## 6. ART IN PUBLIC PLACES

ADDENDUM #1  
CITY COMMISSION  
03/09/15

MEDITERRANEAN VILLAGE  
AT PONCE CIRCLE

# PUBLIC ART LOCATIONS - GROUND FLOOR

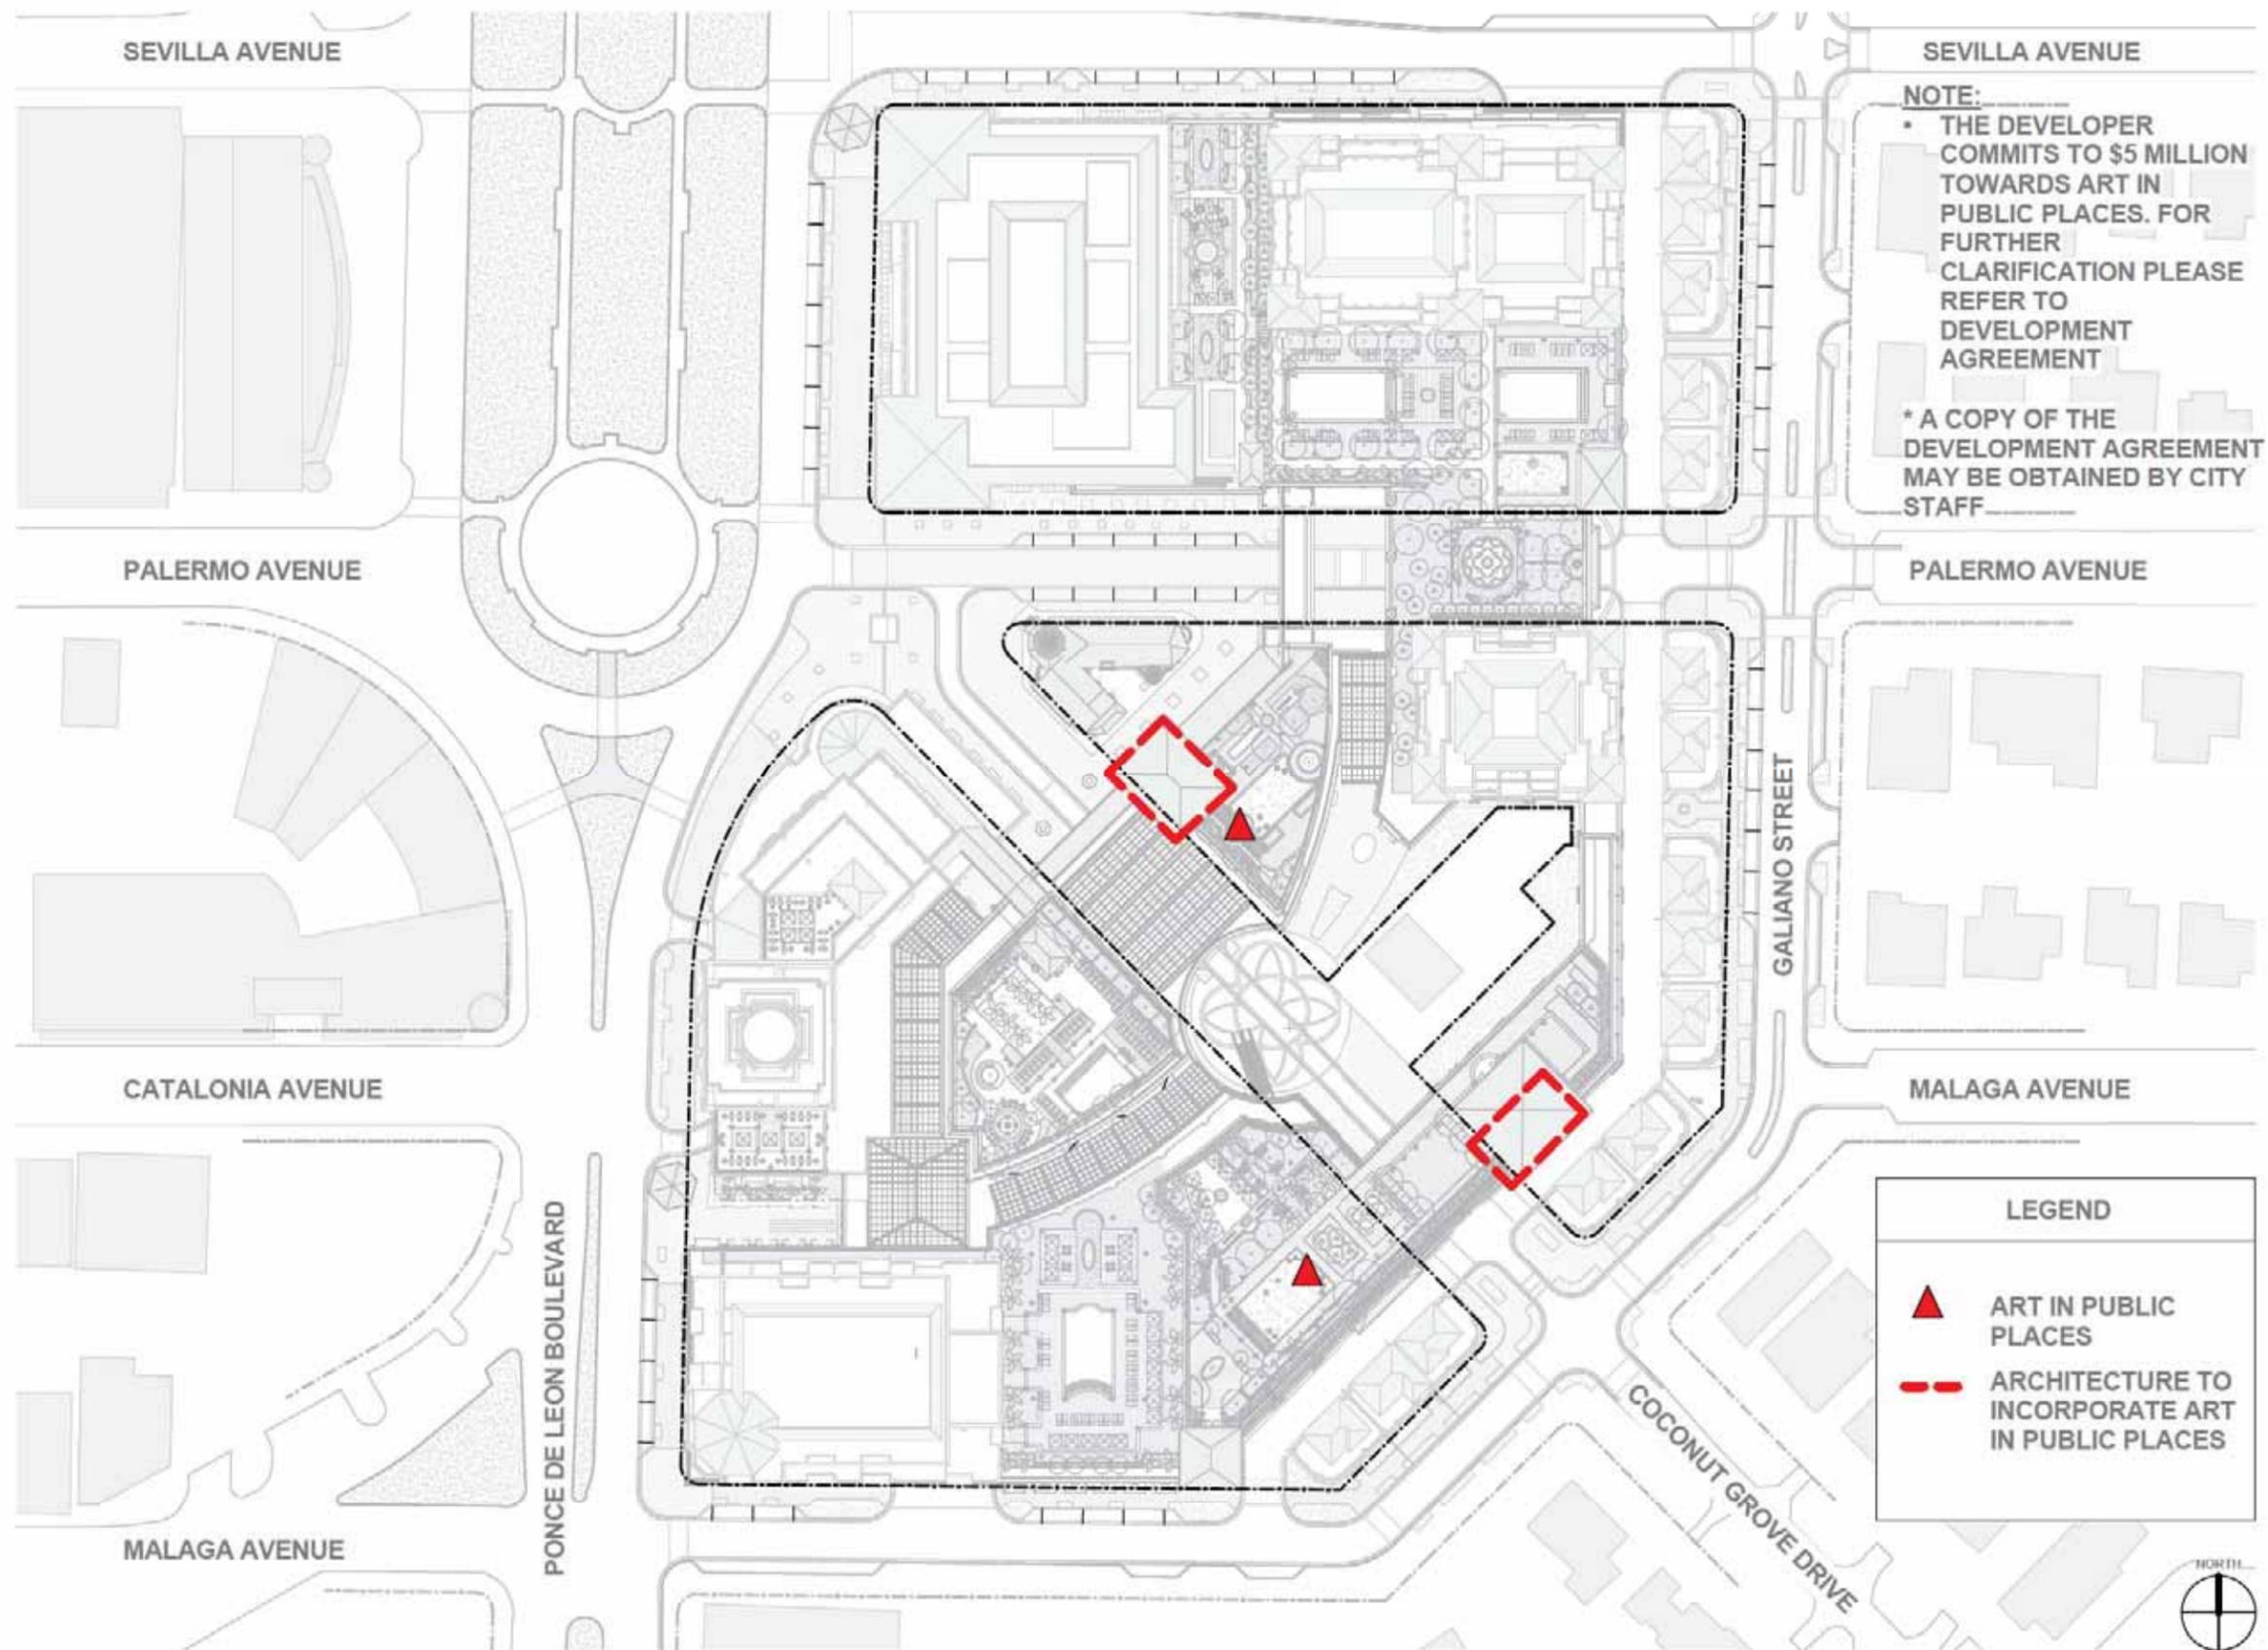
- Determine the percentage contribution that will be made to the program, above and beyond the current requirements of the Zoning Code, subject to the approval of the Director of Economic and Cultural Development.

- THE DEVELOPER COMMITS TO \$5 MILLION TOWARDS ART IN PUBLIC PLACES. FOR FURTHER CLARIFICATION PLEASE REFER TO DEVELOPMENT AGREEMENT
- \* A COPY OF THE DEVELOPMENT AGREEMENT MAY BE OBTAINED BY CITY STAFF

# ARCHITECTURAL SITE PLAN - CENTRAL PARCEL

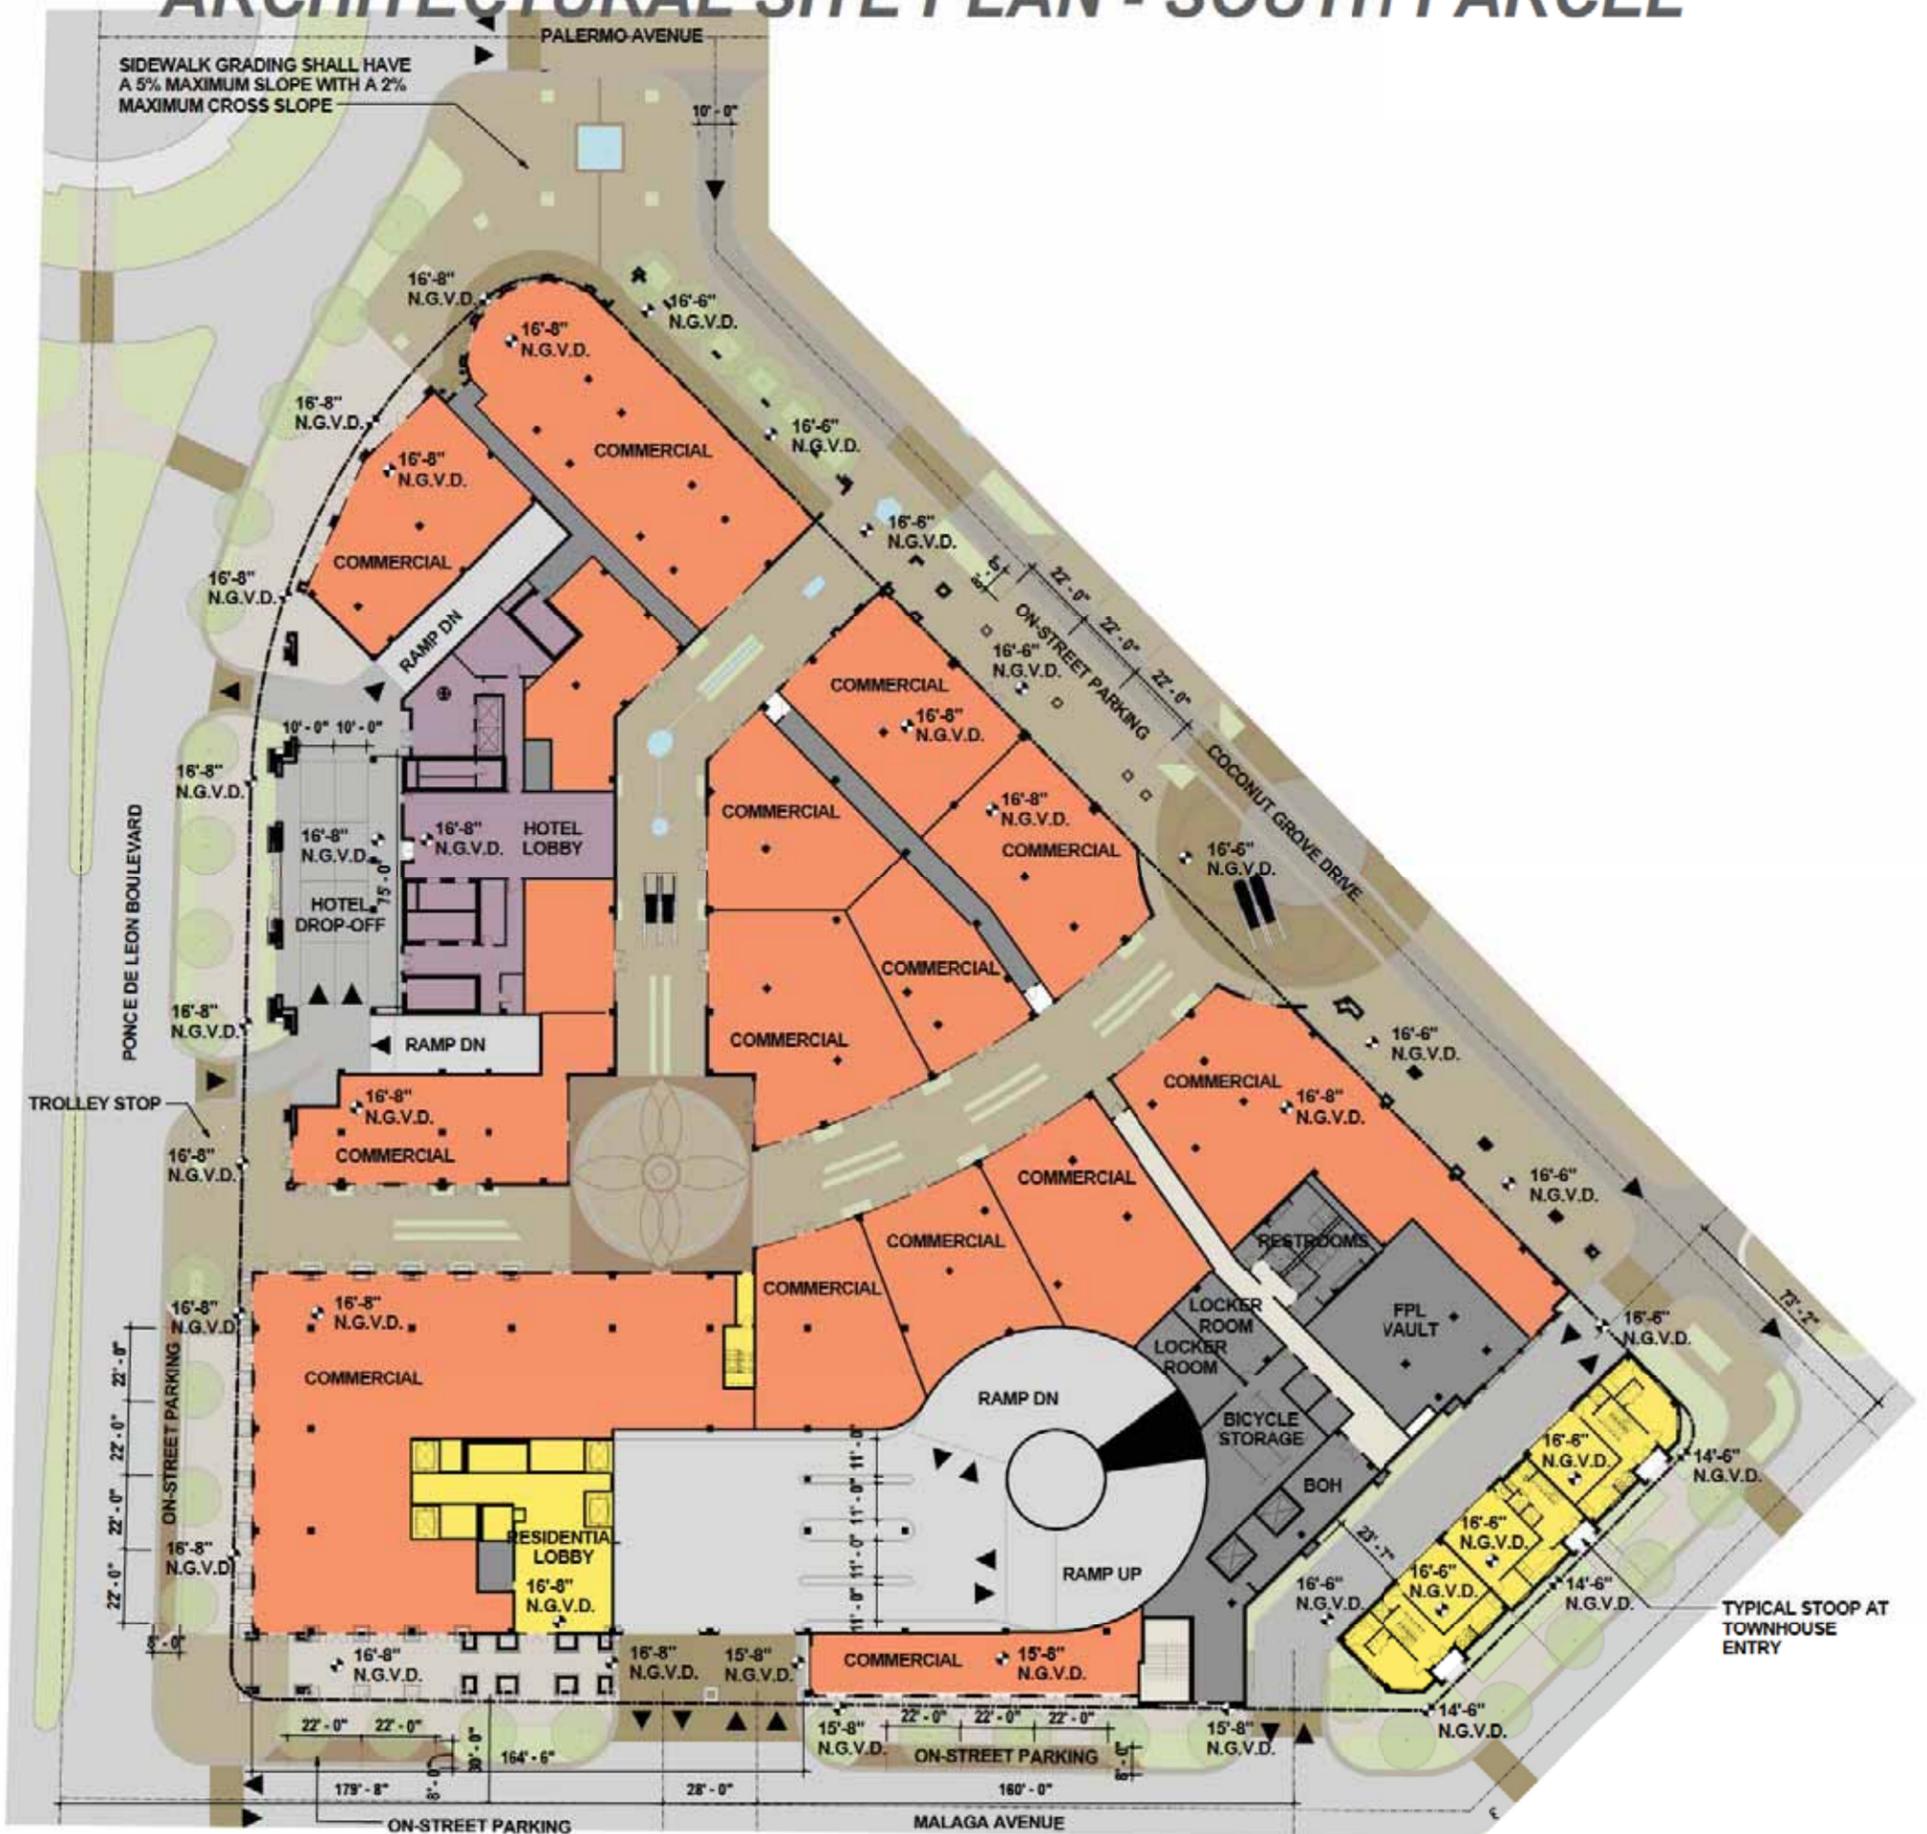
**- Grade changes that result from the construction of the underground parking garage shall be addressed and fully explained in a pedestrian open space plan, in particular addressing the sidewalk and storefront entrances along Ponce de Leon Boulevard, Sevilla Avenue, and Malaga Avenue, and around the Arts Center Building and the existing single-family residence. All steps and ramps between levels shall be fully designed and clearly marked on the plans.**

- NOTE:**
- SITE PLANS INCORPORATE CONCEPTUAL GRADING FOR ALL BUILDING ENTRANCES TO BE FLUSH WITH PUBLIC SIDEWALKS
  - IT IS IN THE BEST INTEREST OF THE DEVELOPMENT FOR ALL SIDEWALKS TO BE FLUSH WITH BUILDING ENTRIES

# SINGLE FAMILY RESIDENCE CONSTRUCTION ACCESS DIAGRAM

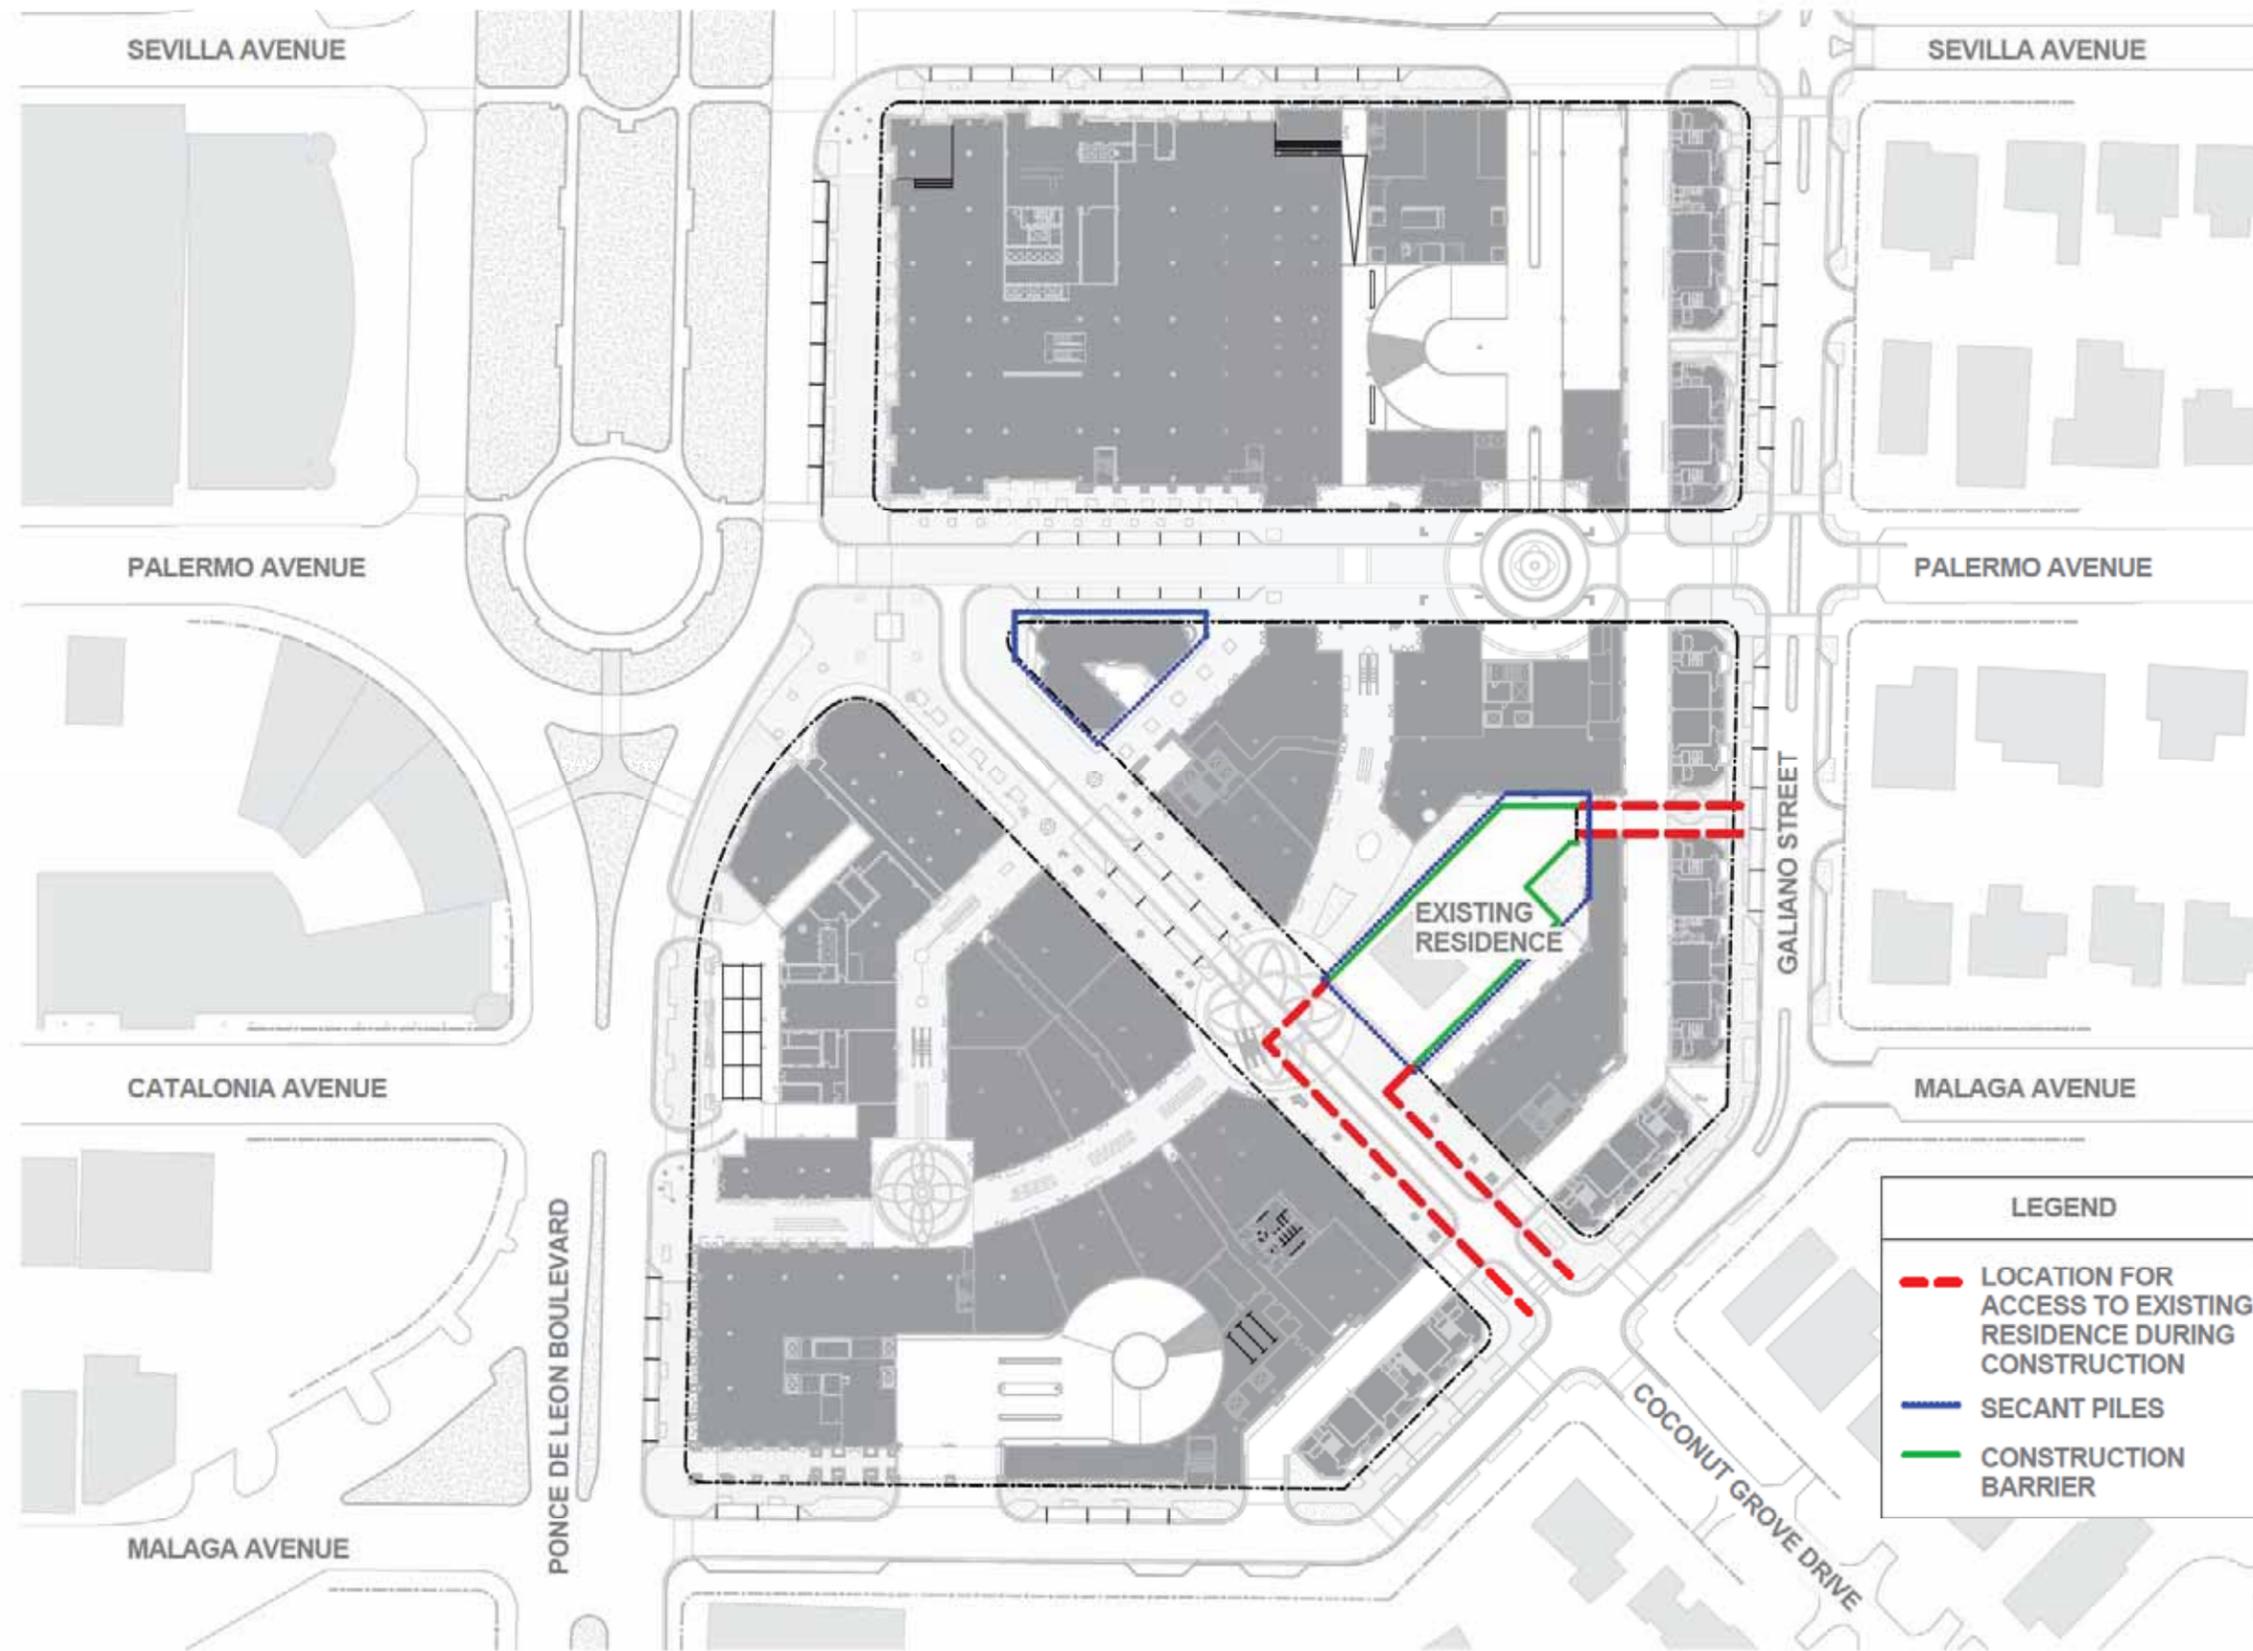
- A construction staging plan needs to be prepared to demonstrate the feasibility and appropriateness of constructing the above-ground parking garage, cinema, roof top park, and retail areas to the east of the existing single-family residence.

- NOTE:**
- ACCESS AND PUBLIC UTILITIES TO EXISTING RESIDENCE SHALL BE MAINTAINED DURING CONSTRUCTION OF THE PROJECT.
  - A COMPLETE CONSTRUCTION STAGING PLAN WILL BE SUBMITTED PRIOR TO ISSUANCE OF BUILDING PERMIT.
